LHAP MSCP (SSD 10388) - Addendum Letter

Liverpool Hospital
Elizabeth Street, Liverpool
NSW 2170
200811 SSDA MSCP Addendum (01)

APPENDIX A – ARCHITECTURAL DRAWING AMENDMENTS

DRAWING
SHADOW DIAGRAMS
PRINT DATE
11/08/2020

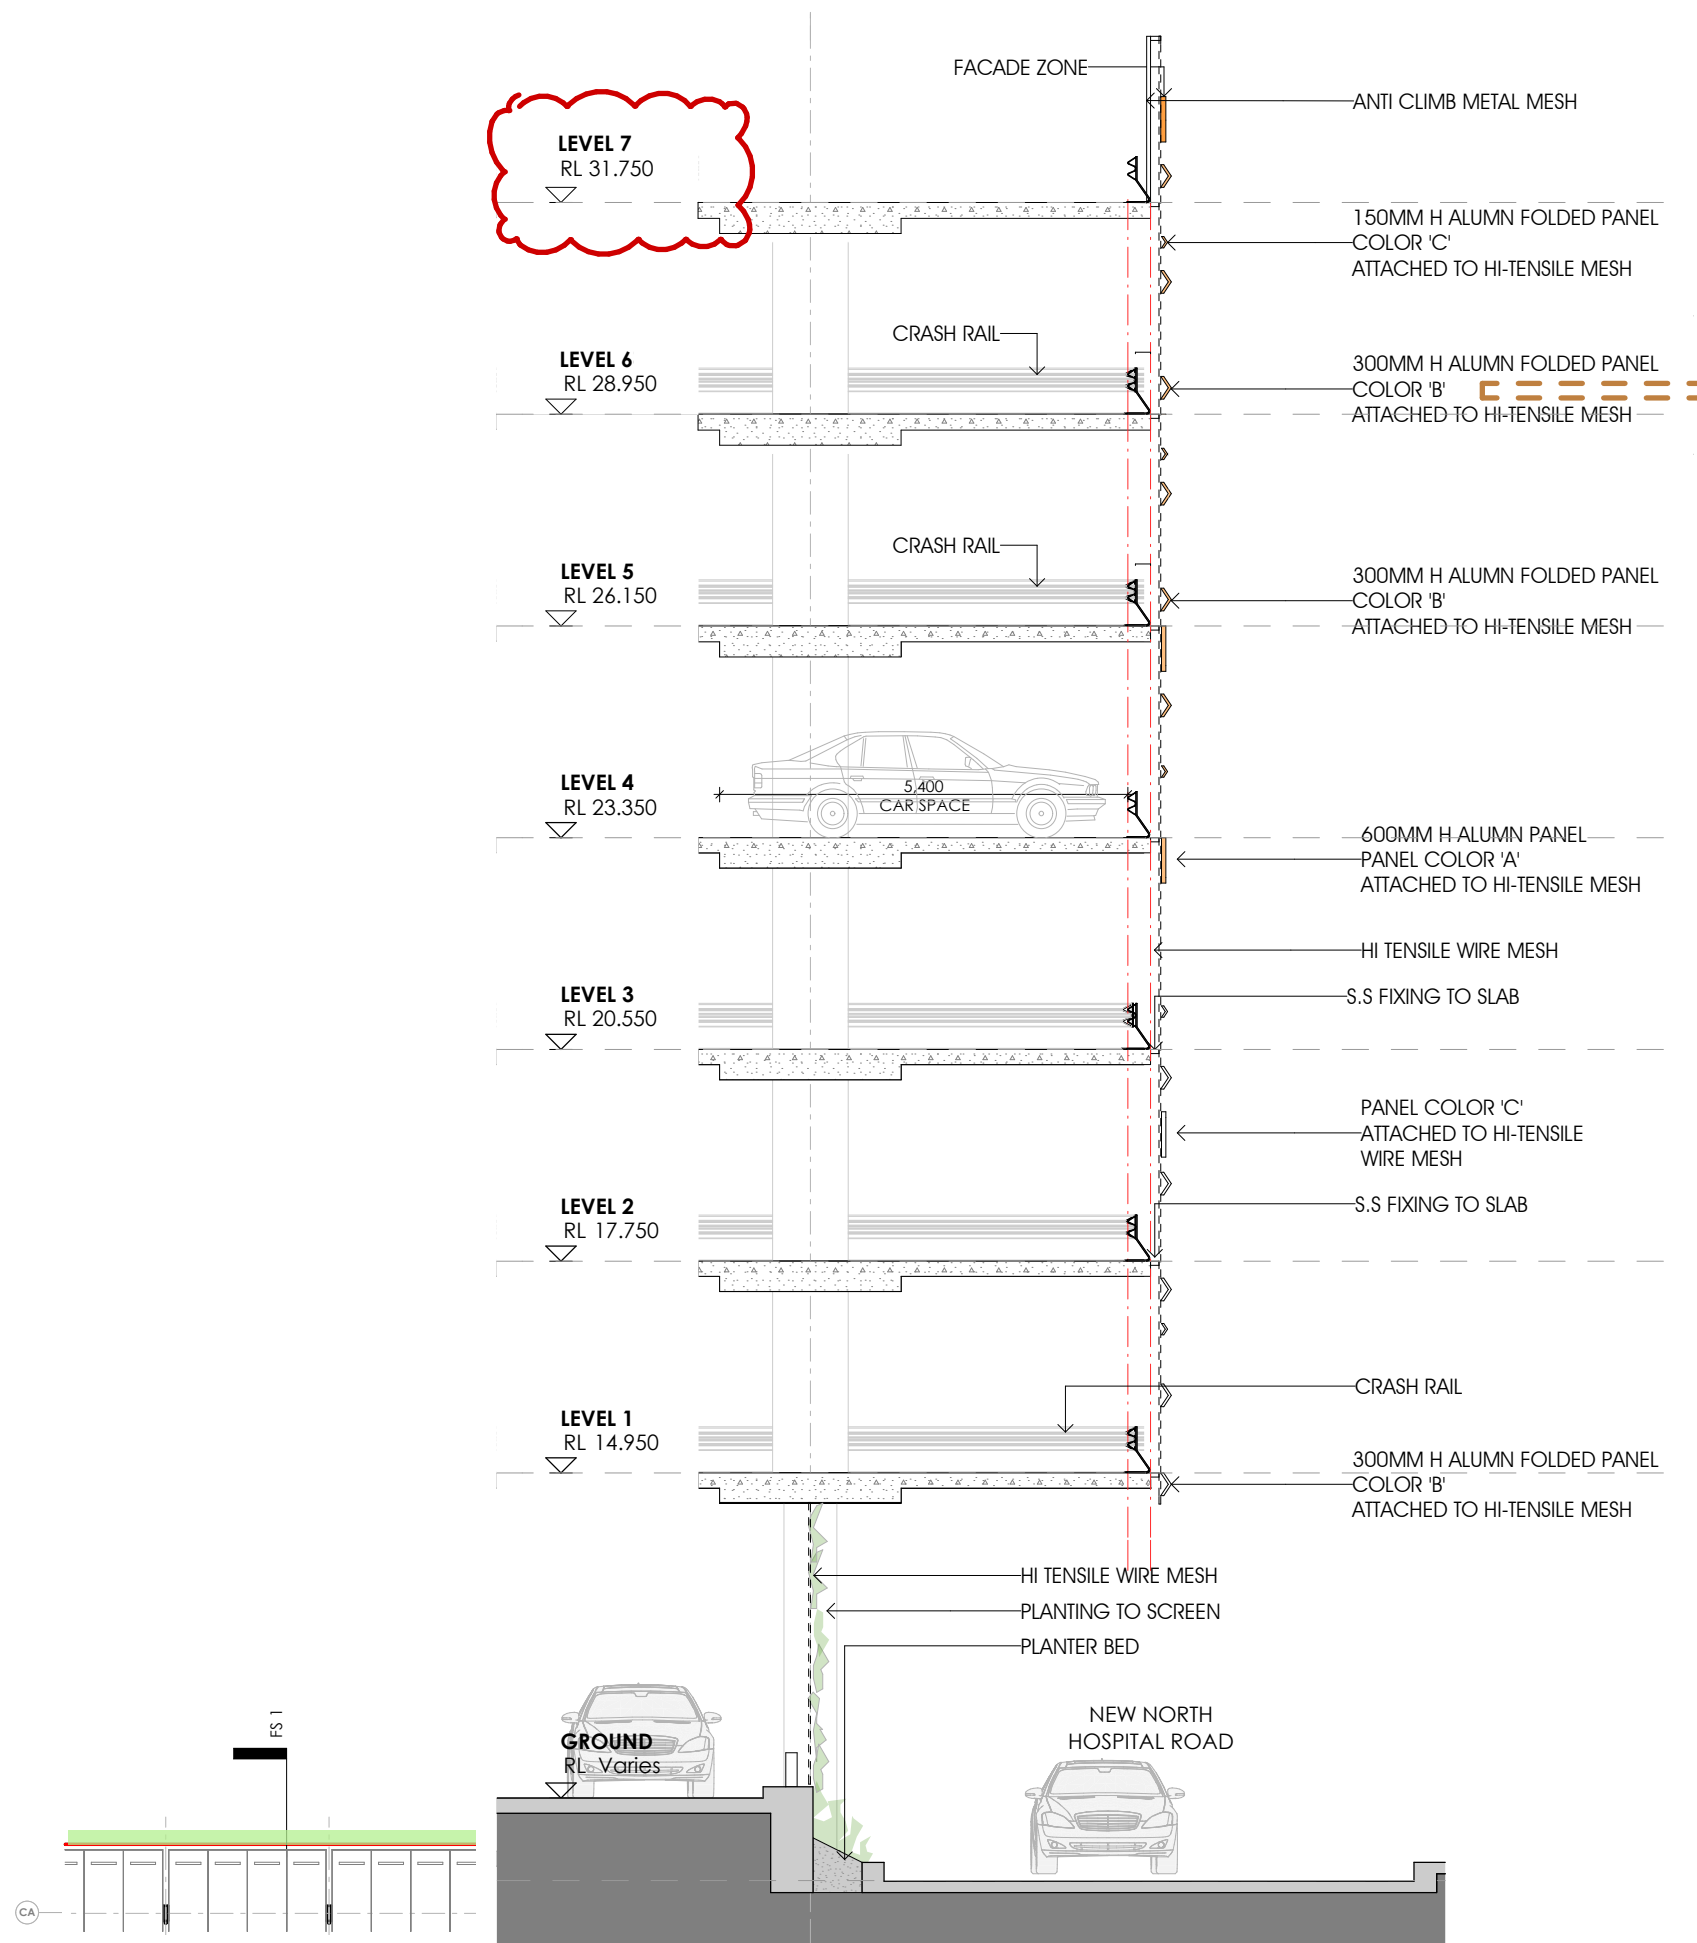
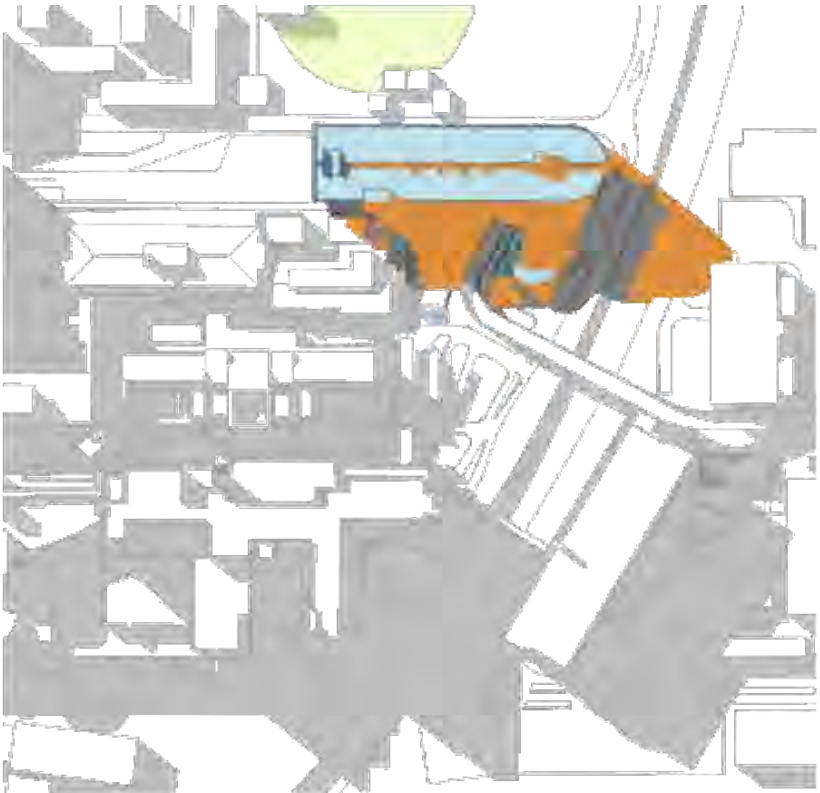
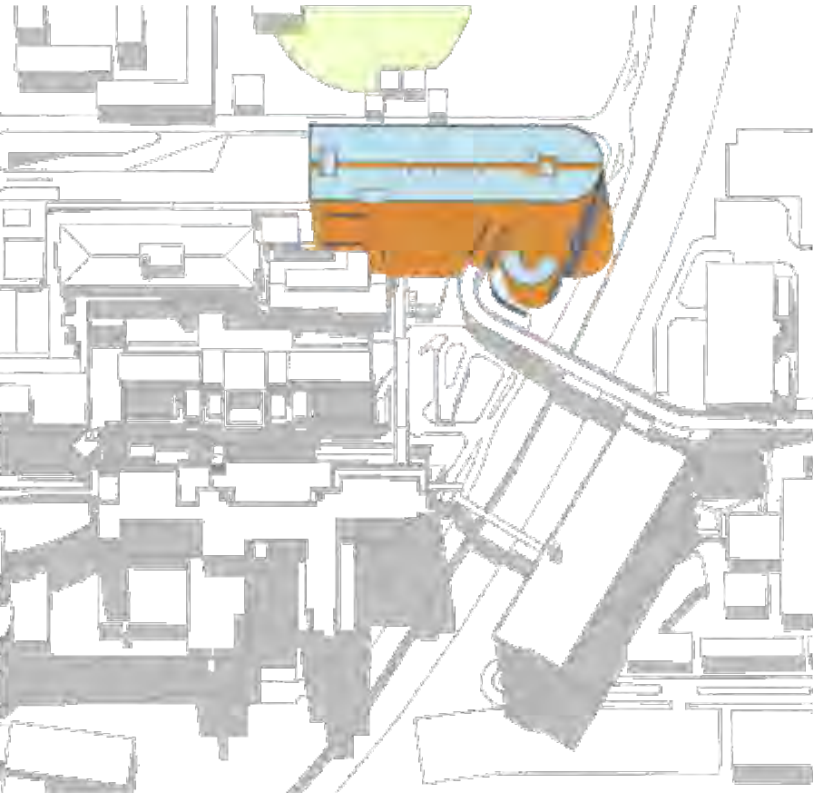
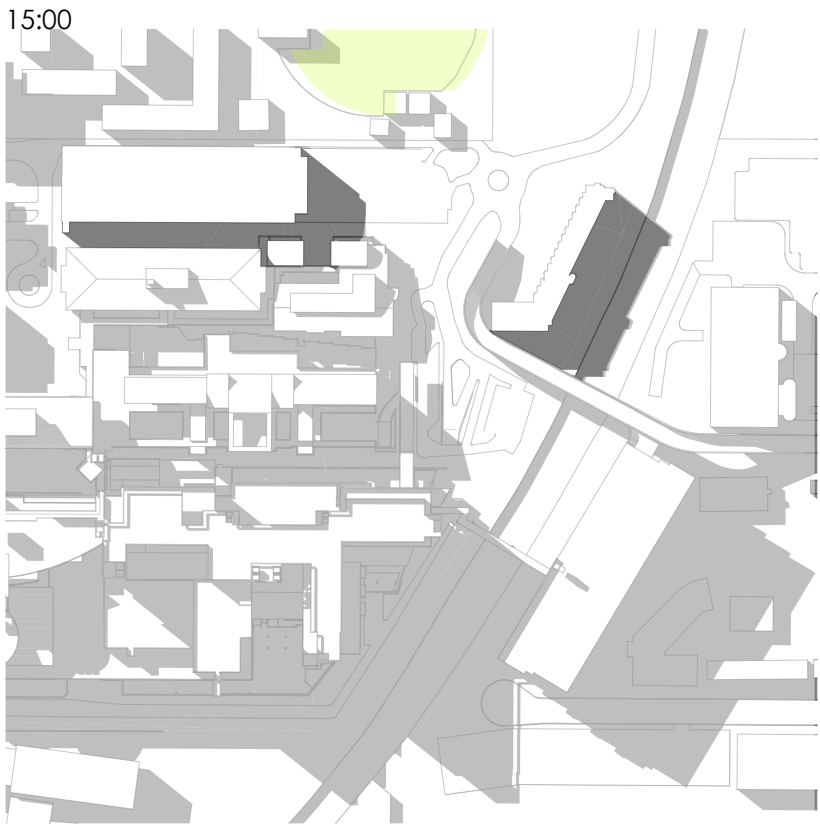
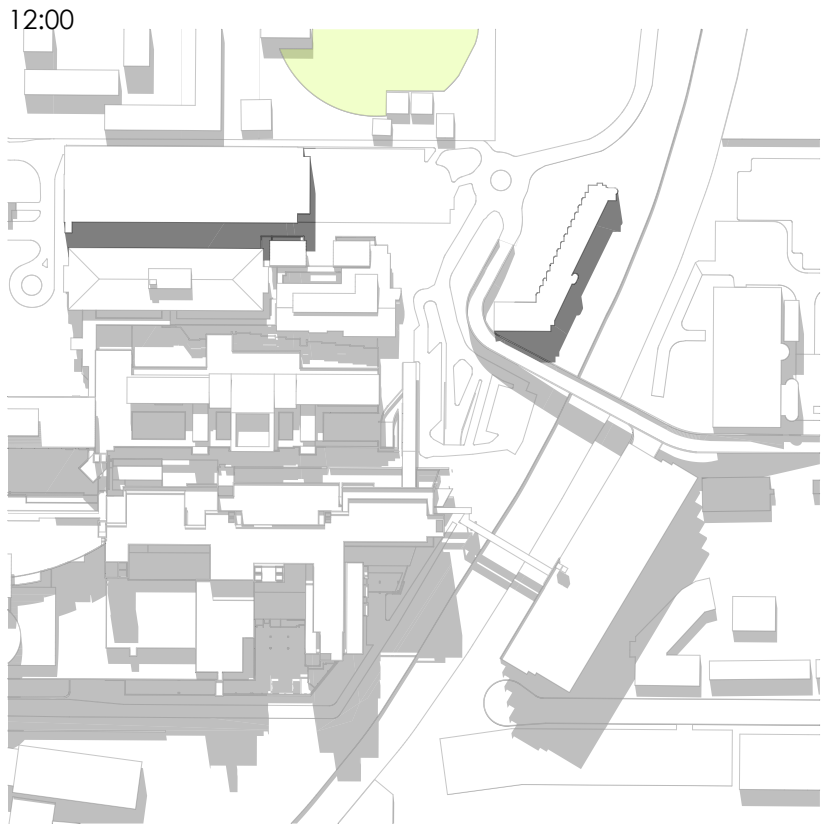
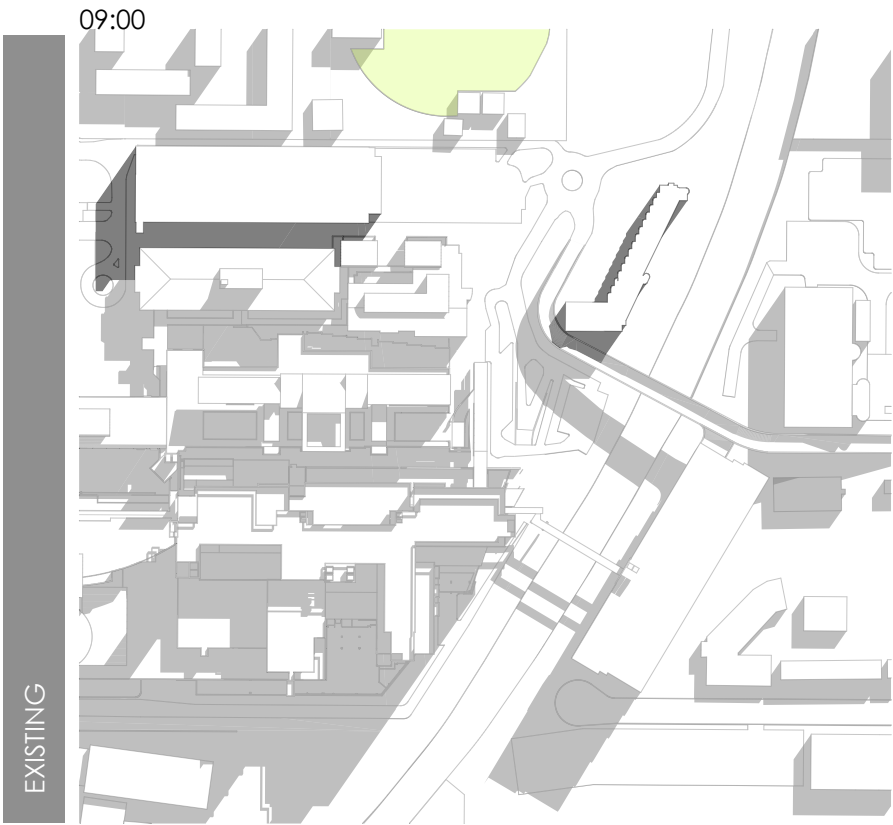
A-SSDA-MW-24 SHADOW DIAGRAMS (amended drawing)

- Shadows amended to incorporate additional level (Level 7)

additional shadow impact on site

DRAWING
VISUAL IMPACT ASSESSMENT
PRINT DATE
11/08/2020

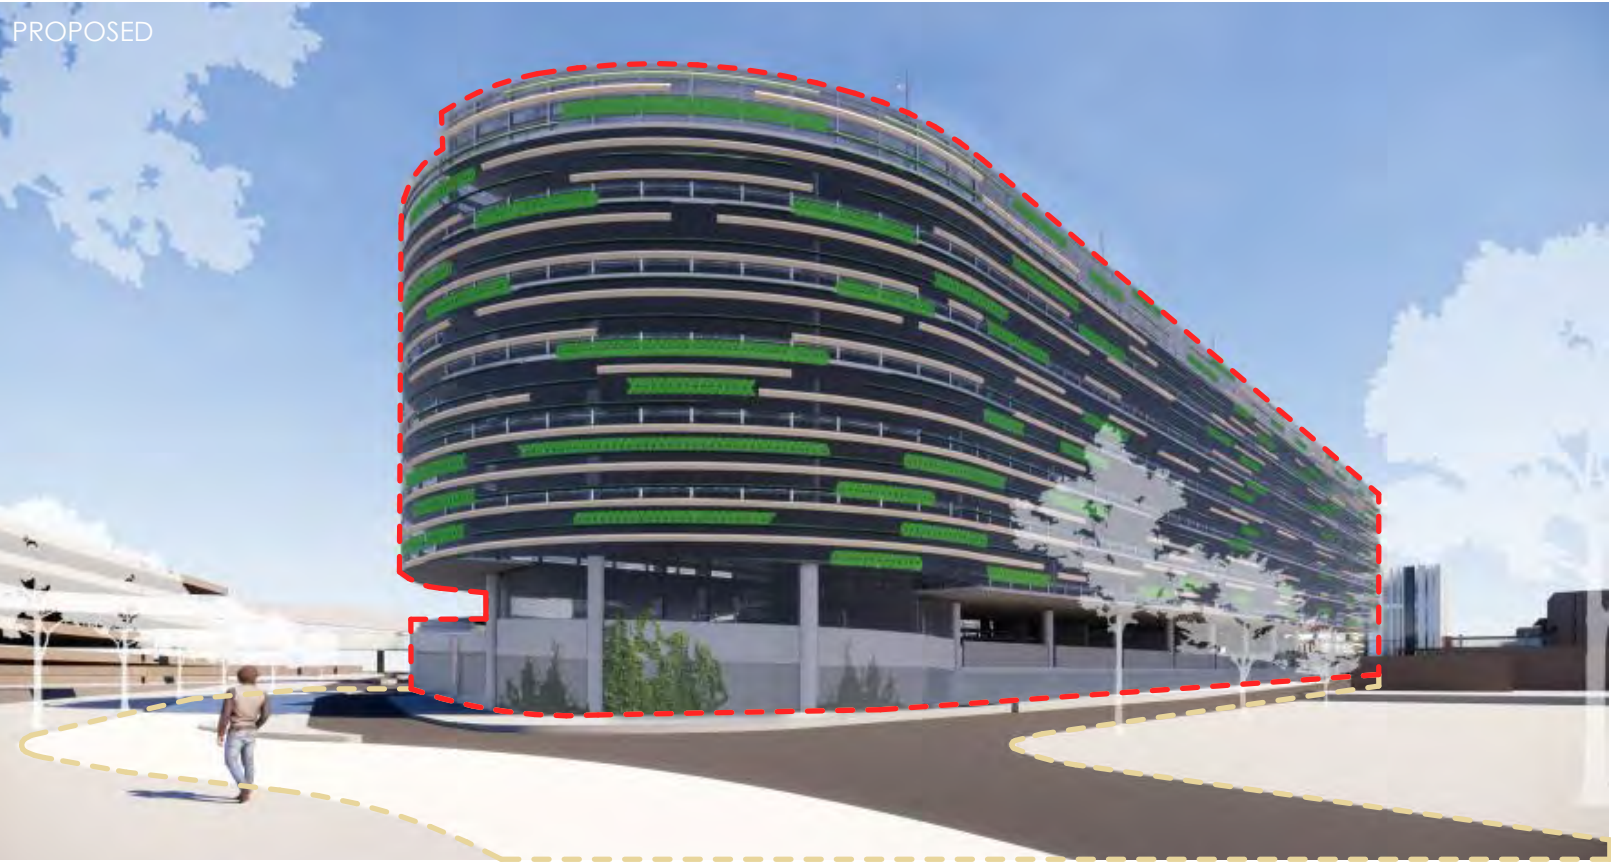
A-SSDA-MW-25 VISUAL IMPACT ASSESSMENT (amended drawing)

- Additional level (Level 7) added

LEVEL 7 ADDED
